E8362BH85-02**S E R V I C E N O T E**Supersedes:
NONE**E8362BH85 PNA Microwave Network Analyzer**

Serial Numbers: 0000A00000/9999Z99999

Situation:

Figure 1: A3 Front Panel Interface Board Assy without the Bracket

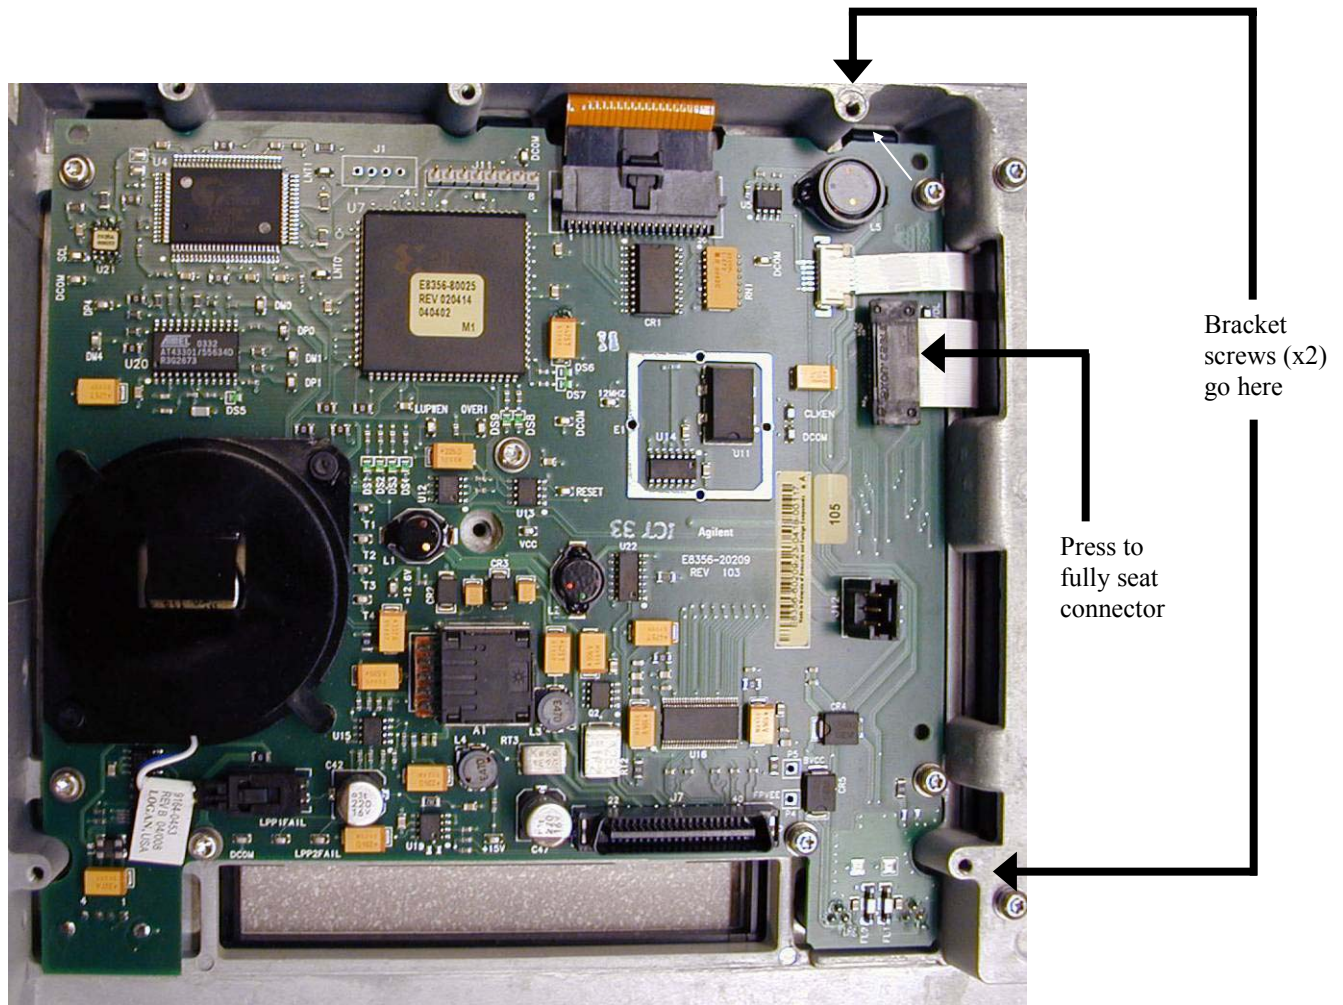
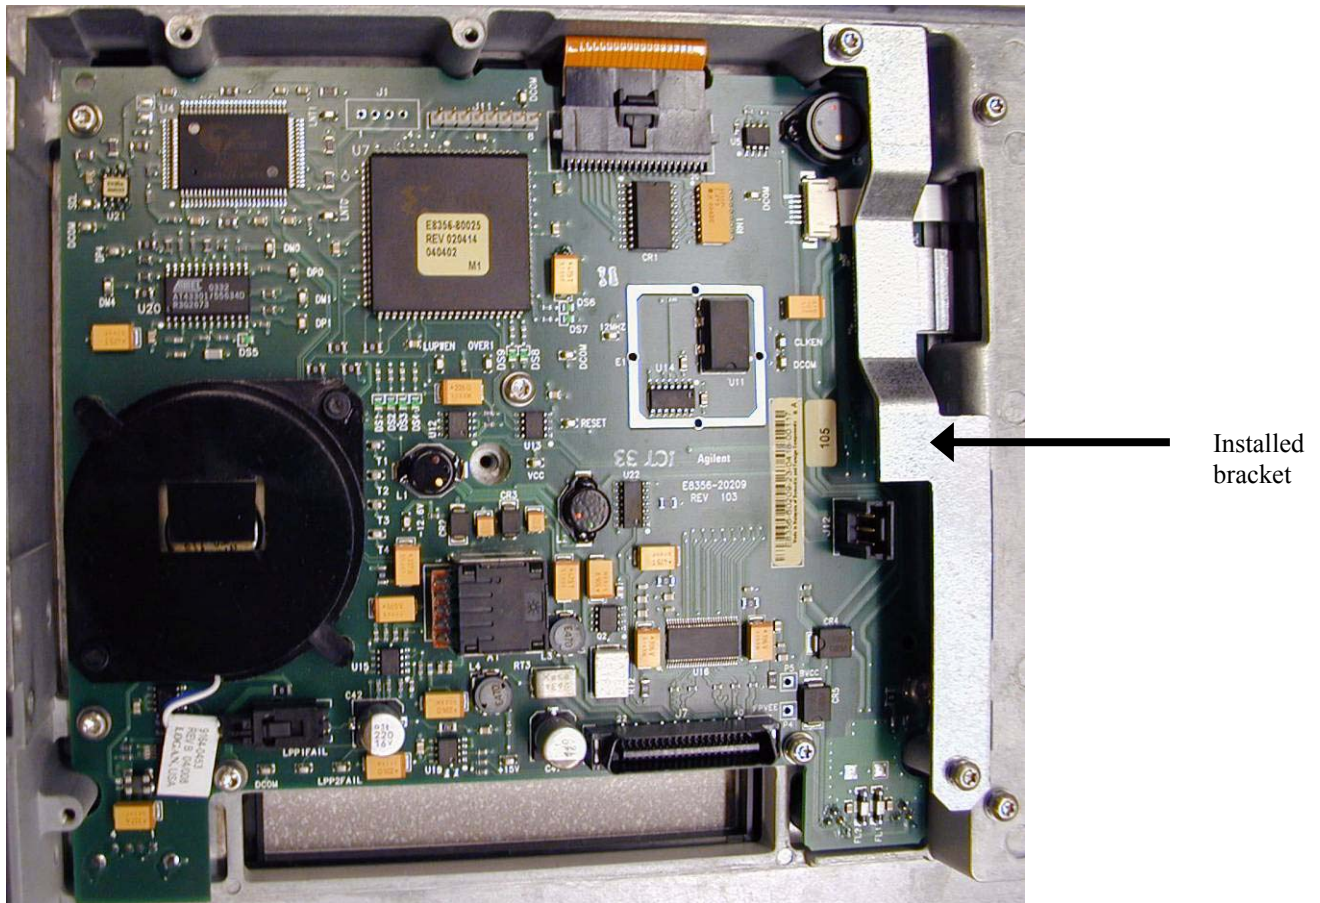
A connector of the ribbon cable (Agilent part number 8120-8409) that joins the front panel display to the front panel interface board can loosen, causing a display failure, unless a new bracket is installed. Because the failure rate has been very low, it is recommended that the bracket be installed only when there is an additional reason to remove the PNA front panel.

1. Refer to Figure 1 in this document:
 - Press down firmly on the ribbon cable's black connector.
 - Locate the two tapped holes for the bracket screws.
2. As shown in Figure 2 in this document, position the bracket so that its holes line-up with the two holes you located in the previous step.
3. Hand-start the two screws, and then torque both to 9 in-lbs.
4. Reinstall the PNA Front Panel by following the Service Guide instructions in the "Replacement Procedure." This is located on the same page as the "Removal Procedure" used previously in step 7.
